4051 CPU BOARD TO EXTENDED MEMORY BOARD CABLE INSTALLATION

Figure 1 CORRECT CABLE INSTALLATION

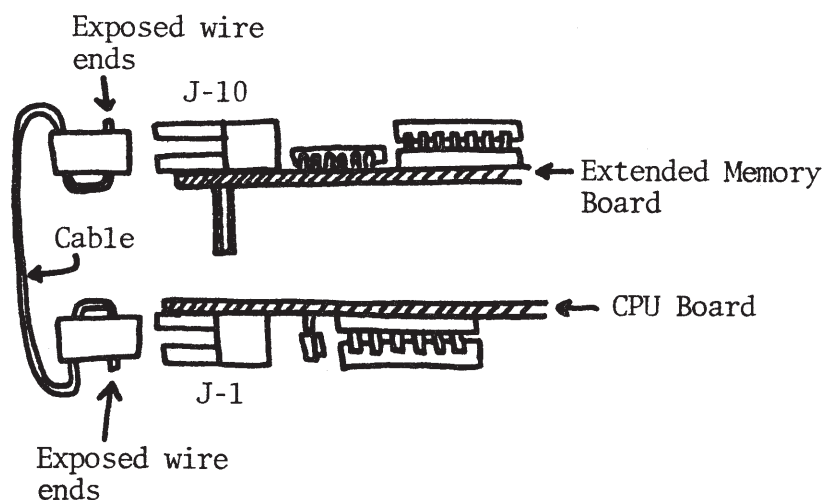
Ron Kersey, of the Module Repair Center, has noticed that the cable connecting the 4051 extended memory (J-10) board to the CPU board (J-1) can cause catastrophic failures if not properly installed. When the cable P/N 175-1726-00 is manufactured, the ribbon cable is sandwiched in the plug. The end of the ribbon cable extends out of the plug with the ends of the cable exposed. When installed, these wire ends will short to the board (+12 volts on the CPU, ground on the EXT MEM). This will blow out I.C.'s on the CPU board, the extended memory, and the backpack. To prevent this damage, install the cable so that the wire ends are away from the board.
